# **State of Response to LRD Opinion**

**Prepared in Respect of a Planning  
Application for a Large-Scale Residential  
Development (LRD) at a Site of 5.48 Ha in  
Ratoath, Co. Meath**

**On behalf of Marshall Yards Development  
Company Limited**

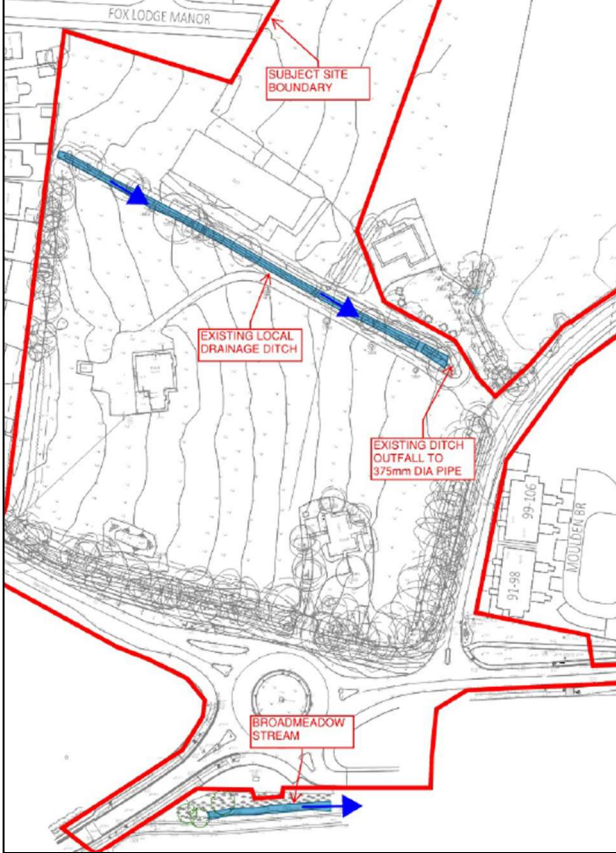
(m) The Compact Settlement Guidelines (January 2024) have introduced minimum private open space and maximum semi-private (in lieu) space requirements. The final iteration of the application which is submitted should ensure that such standards have been met, noting that housing developments which provide private open space at the minimum standard throughout the scheme will be discouraged (as per Section 11.5.12 of the MCDP).	All private amenity space requirements have been met or exceeded. Please refer to JFA's <i>Housing Quality Assessment</i> and <i>Site Layout Plan West</i> .
